Service information

Reference no.: SDA_97593

1W and 0.5W Power Board and Control Board

Products affected: GC82xx, GC83xx

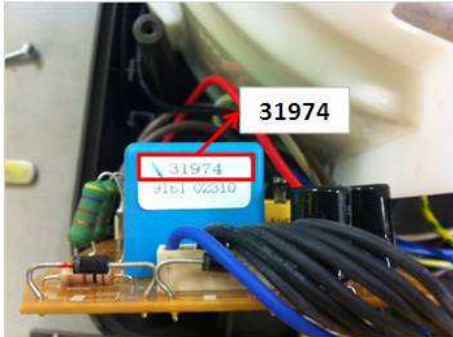
Power Board PCB Assy upgraded from 1W to 0.5W standby power..

| CTN | Return set GC82xx, GC83xx | Repair option |
|-------------------|--|--|
| GC82xx, GC83xx | **If Control Board PCBA Assy (Pos 44) is 4239 021 56871 or 4239 021 56881 or 4239 021 31969 | Option 1* Pos 43: Replace Power Board PCBA Assy, 4239 021 31970 |
| | | Option 2 (Must replace both Power Board and Control Board) Pos 43: Replace Power Board PCBA Assy, 4239 021 73241 and Pos 44: Replace Control Board PCBA Assy, 4239 021 73231 |
| | If Control Board PCBA Assy (Pos 44) is 4239 021 73231 | Option 3 Pos 43: Replace Power Board PCBA Assy, 4239 021 73241 |

* If Repair Option 1 Power Board PCBA Assy, 4239 021 31970 is not available, pls use Repair Option 2.
